13382  
29 April 2014

**ADDENDUM TO RESPONSE TO SUBMISSIONS SSDA6 - SSD 13\_6116  
SICEEP – ICC HOTEL**

We refer to the Response to Submissions (RtS) submitted to Planning and Infrastructure on 26<sup>th</sup> March 2014 in relation to the International Convention Centre (ICC) Hotel (SSDA6).

Figure 4 – Reduced height proposal and shadow cast at 3.00pm on the winter solstice

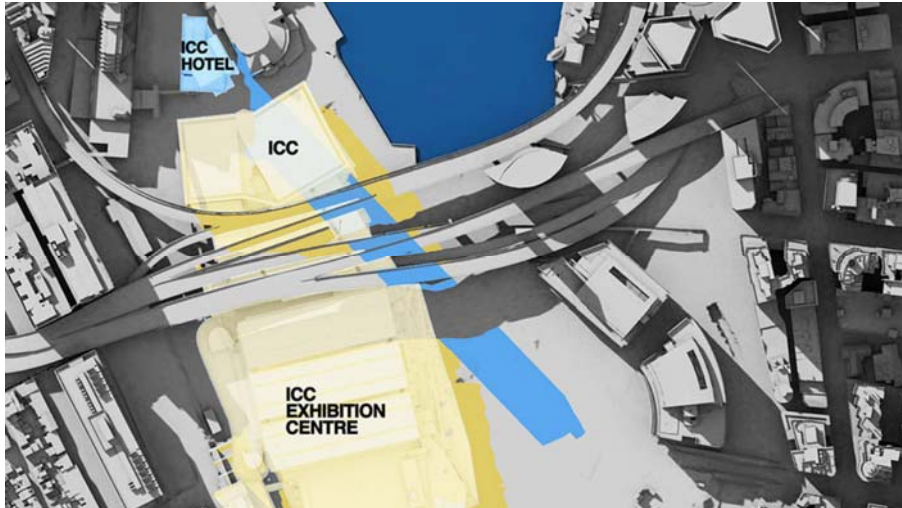
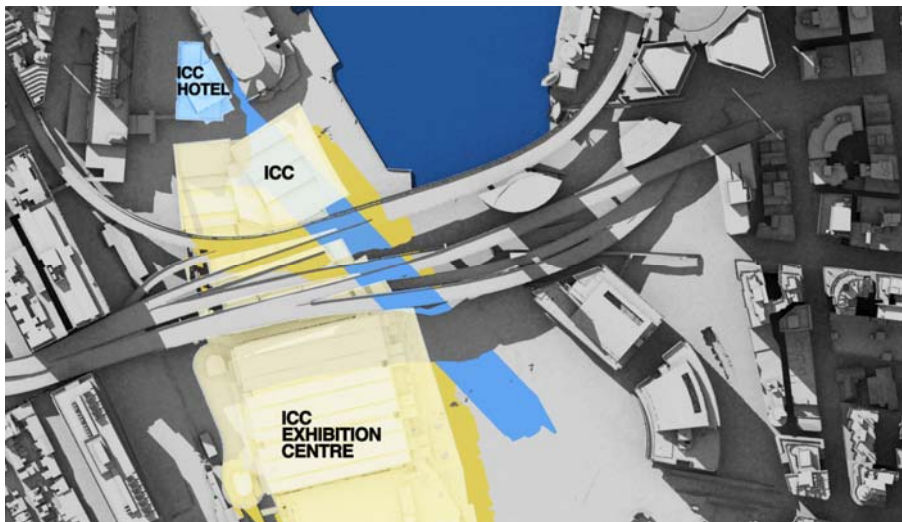
With further consideration of comments raised during the public exhibition period, Lend Lease has made amendments to the building height of the Hotel tower (reducing the height of the tower by 3 storeys). This change addresses comments raised by the general public and the City of Sydney Council, where concern was raised in relation to overshadowing impacts on the public realm.

The refinement to the number of Hotel tower floors and consequential reduction in height by three storeys has a positive environmental impact in that it reduces the extent of overshadowing cast by the Hotel upon the public realm (i.e. Tumbalong Park) and surrounding buildings (i.e. Goldsbrough Mort Apartment Building). This is highlighted within the revised shadow analysis prepared by Virtual Ideas (refer to **Attachment D**). A comparison below of the RtS scheme and its shadow cast at 3.00pm on the winter solstice across Tumbalong Park and the amended scheme illustrates the positive outcome in terms of reduced overshadowing impacts.
